Access Compliance Report

Public Rights-of-Way

(Curb Ramps)

| Intersection ID: 21456 | Main Street: REGENT RIDGE LN | Cross Street: WITHERS MILL DR | Location: NW |

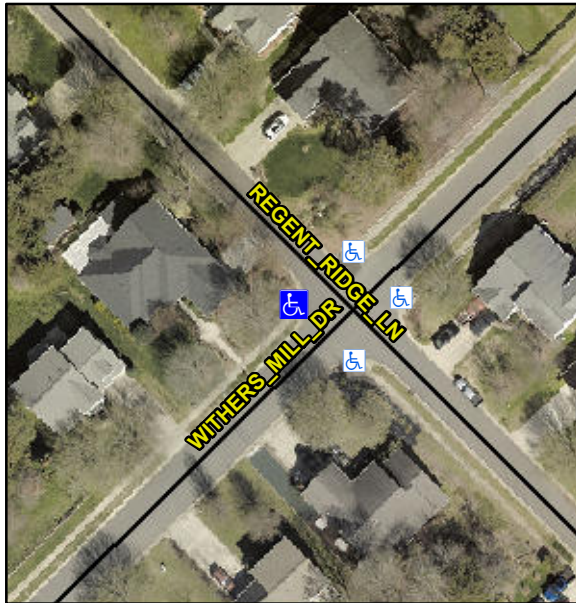
| ADA ID: 96C9D3C66345 | Ramp Type: PerpDiag | Initial Pass/Fail: Fail | Overall Compliance: No |

R304.5.1, R304.5.3

| Compliance | Description | Data | Compliance | Description | Data |
|------------|-----------------------|-------|------------|-----------------------------|-------|
| No | Ramp Width (in) | 34.0 | No | Ramp XSlope (%) | 3.4 |

Remove & Replace Curb Ramp With Two New Directional Ramps or Equivalent.
